Re: Indian Point Unit No. 2
Docket No. 50-247
NL-04-100

SUBJECT: Reply to Supplemental Request for Additional Information Regarding Indian Point 2 Stretch Power Uprate (TAC MC1865)

**REPLY TO NRC REQUEST FOR ADDITIONAL INFORMATION REGARDING
PROPOSED LICENSE AMENDMENT REQUEST FOR
INDIAN POINT 2 STRETCH POWER UPRATE**

Figure 1 - Peak Cladding Temperatures

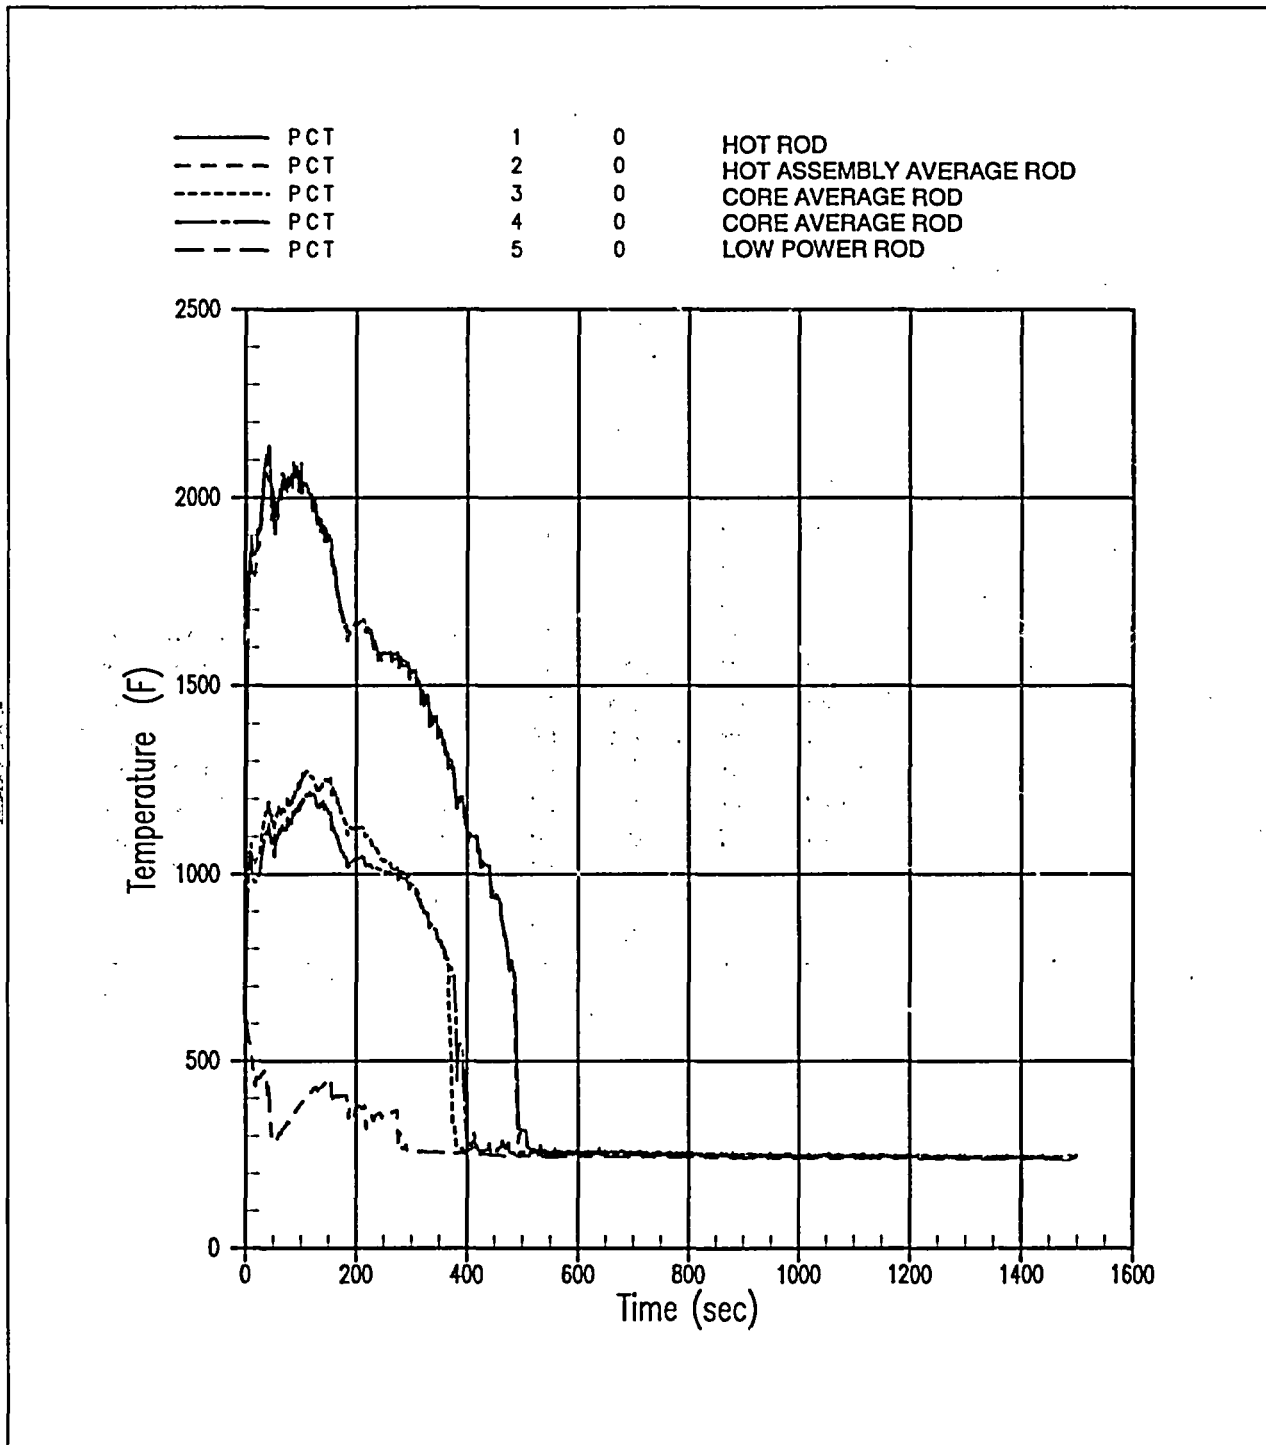
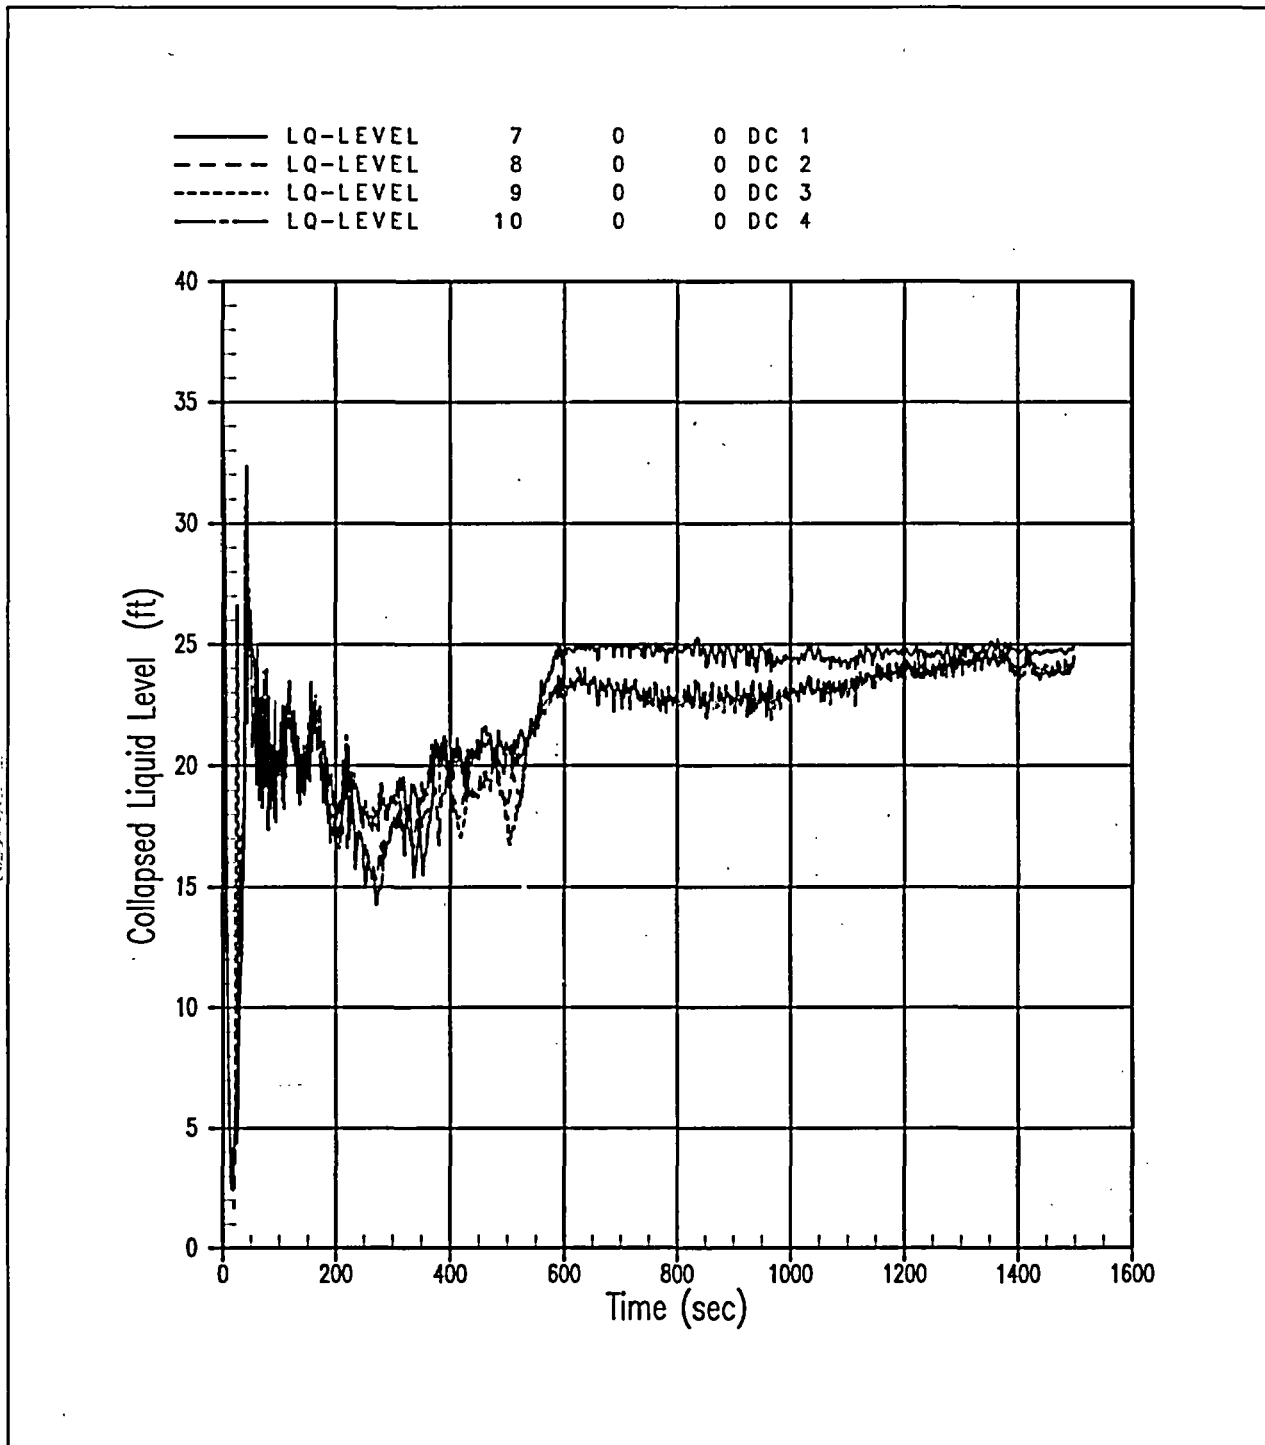
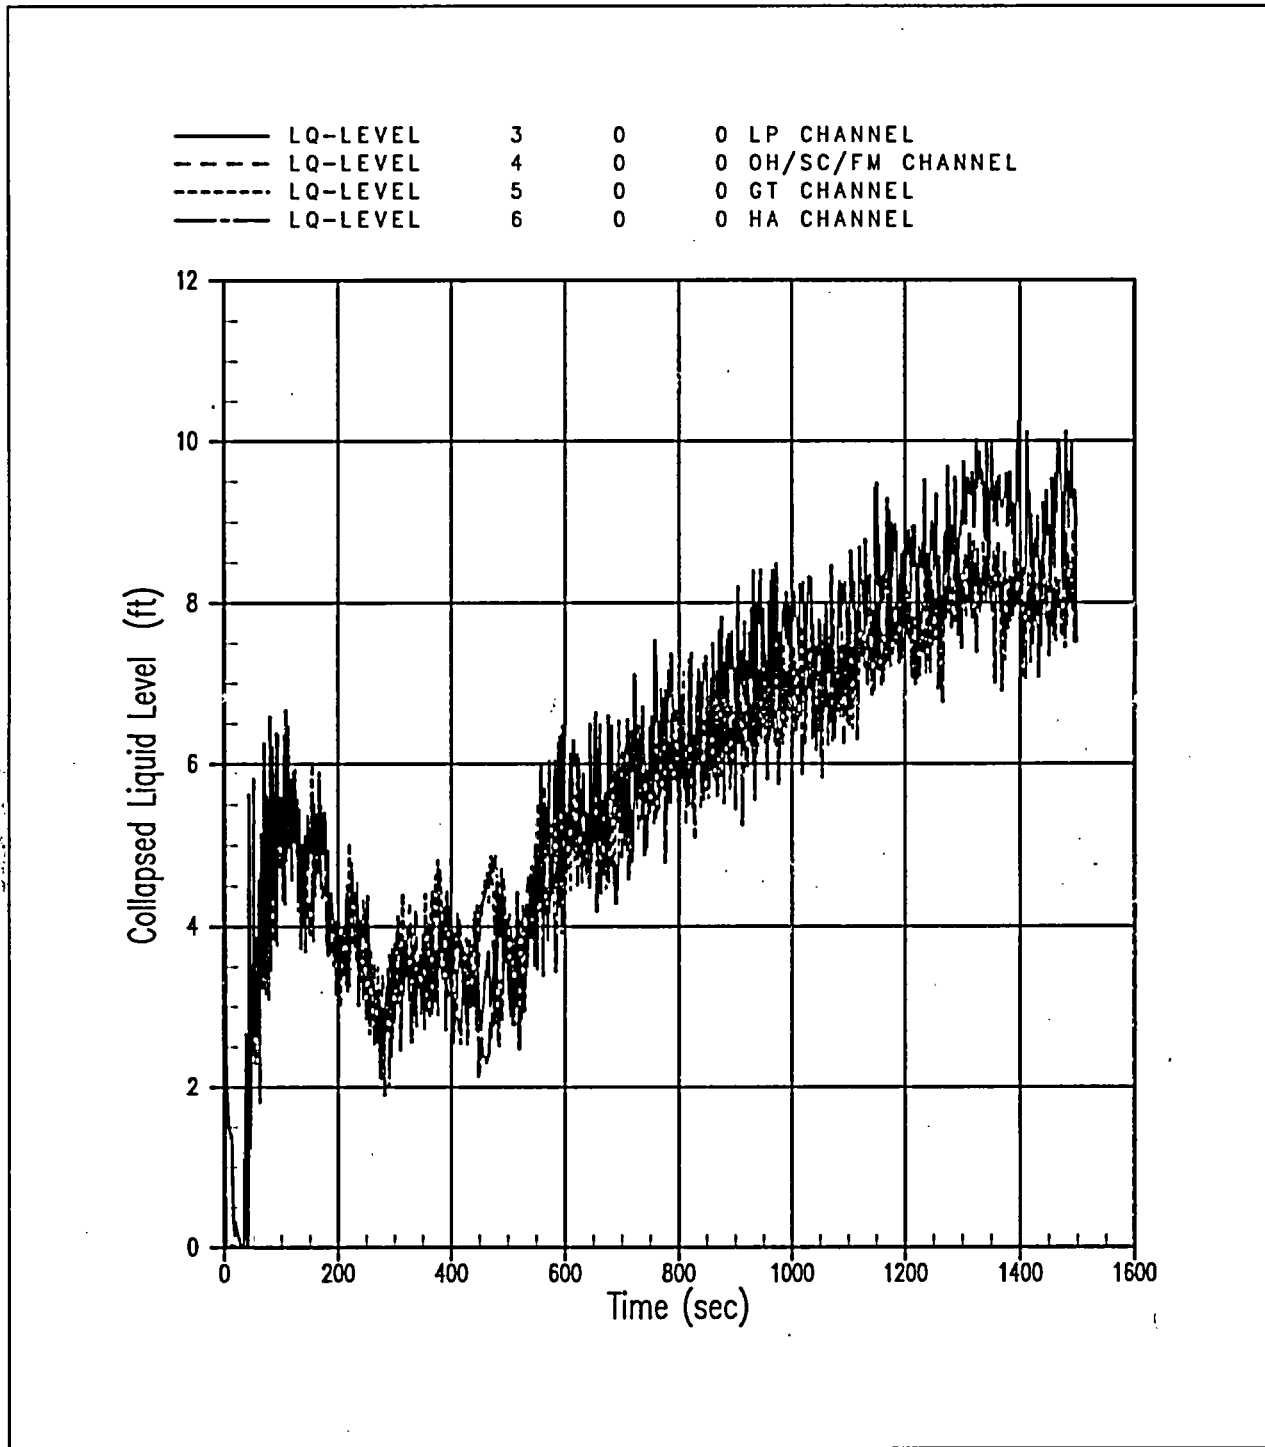
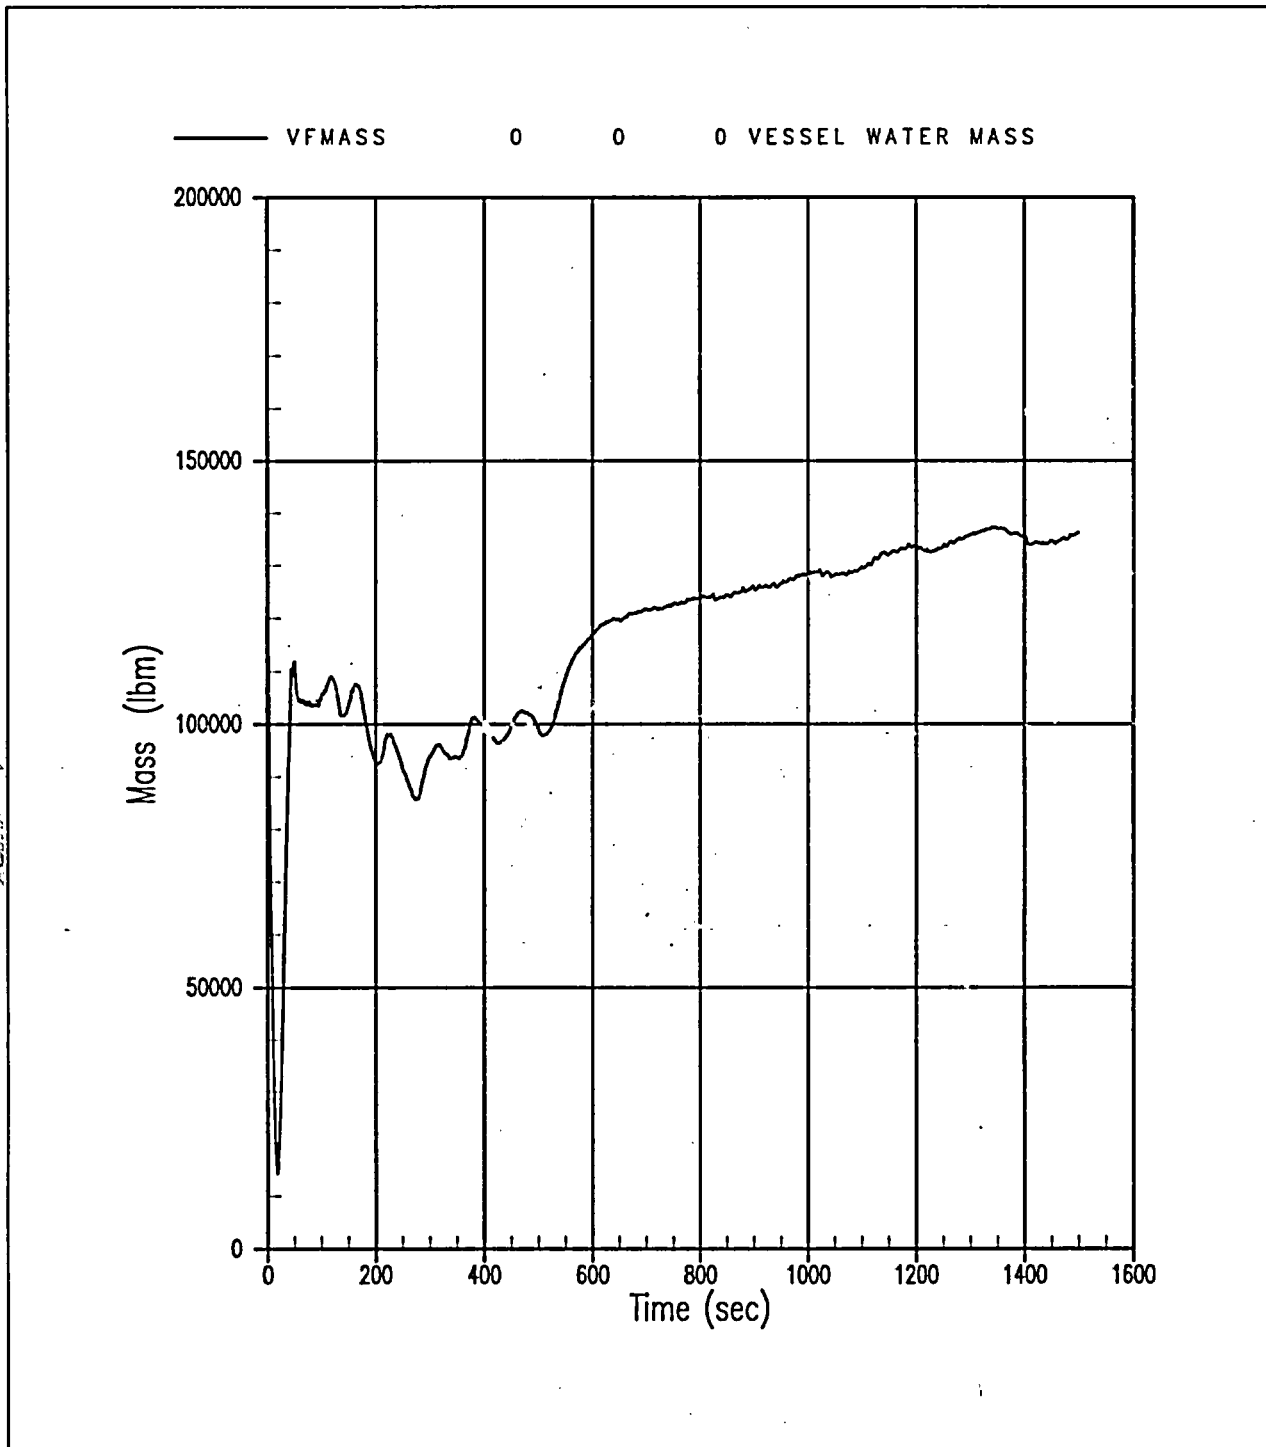
Provide the LBLOCA analysis results (tables and graphs, as appropriate) to the time that stable and sustained quench is established.

In order to demonstrate stable and sustained quench, the WCOBRA/TRAC calculation for the maximum local oxidation analysis was extended. Figure 1 shows the peak cladding temperatures for the five rods modeled in WCOBRA/TRAC. This figure indicates that quench occurs at approximately 275 seconds for the low power rod (rod 5), 400 seconds for the core average rods (rods 3 and 4), and 500 seconds for the hot rod (rod 1) and hot assembly average rod (rod 2). Once quench is predicted to occur, the rod temperatures remain slightly above the fluid saturation temperature for the remainder of the simulation. Figure 2 shows the collapsed liquid level in the four downcomer channels and shows steady behavior, with the level in each quadrant remaining near the bottom of the cold leg. By 600 seconds, bulk boiling in the downcomer has been terminated, and subcooling in the downcomer has been re-established. Figure 3 shows the collapsed liquid level in the four core channels and indicates a gradual increase in the core liquid inventory. This is consistent with the expected result based on the removal of the initial core stored energy and the gradual reduction in decay heat. Figure 4 shows the vessel liquid mass and indicates an increasing trend beginning at about 500 seconds. This indicates that the increase in inventory due to the pumped safety injection is more than offsetting the loss of inventory through the break. Based on these results, it is concluded that stable and sustained quench has been established for the Indian Point Unit 2 Large Break LOCA analysis.

Figure SG-1-1 SG Manway Stud Configuration

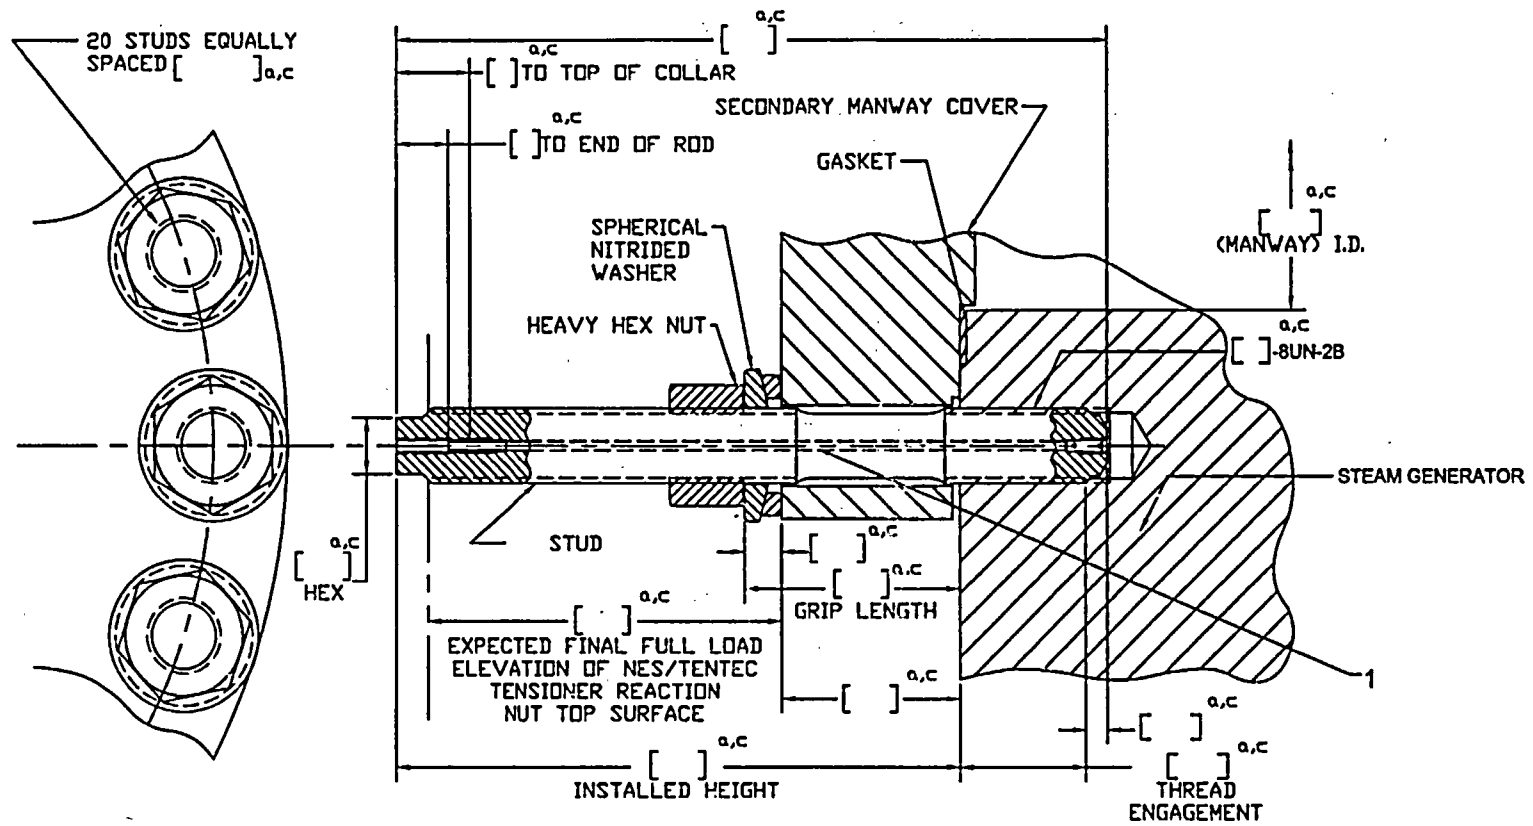
- A. Confirm that you are using secondary manway studs, not secondary manway bolts, in your replacement steam generators, and that the fatigue usage factor for these components is []^{a,c}.
- B. Provide a cross-sectional drawing, which shows how the secondary manway studs are positioned in the licensee's replacement steam generators. The drawing should include the important dimensions and design features of a secondary manway stud and its location relative to the adjoining components.
- C. Indicate on the drawing the areas of highest stress on a secondary manway stud.

The replacement steam generators were designed to accommodate either bolts or studs for secondary manway closure. Thus, values are provided for both in the LAR. The replacement steam generators were installed with studs for secondary manway closure. The fatigue usage value of []^{a,c} as stated in LAR Table 5.6-2 is correct. The attached sketch provides the dimensions and design features of the manway studs as requested. The area of highest stress is also identified as requested.

[1] Maximum stress location corresponds to the threaded section of the stud.

Max stress (w/o uprate) = []^{a,c} ksi < 86.7 ksi (limit)

Max stress (w/uprate) = []^{a,c} ksi < 86.7 ksi (limit)
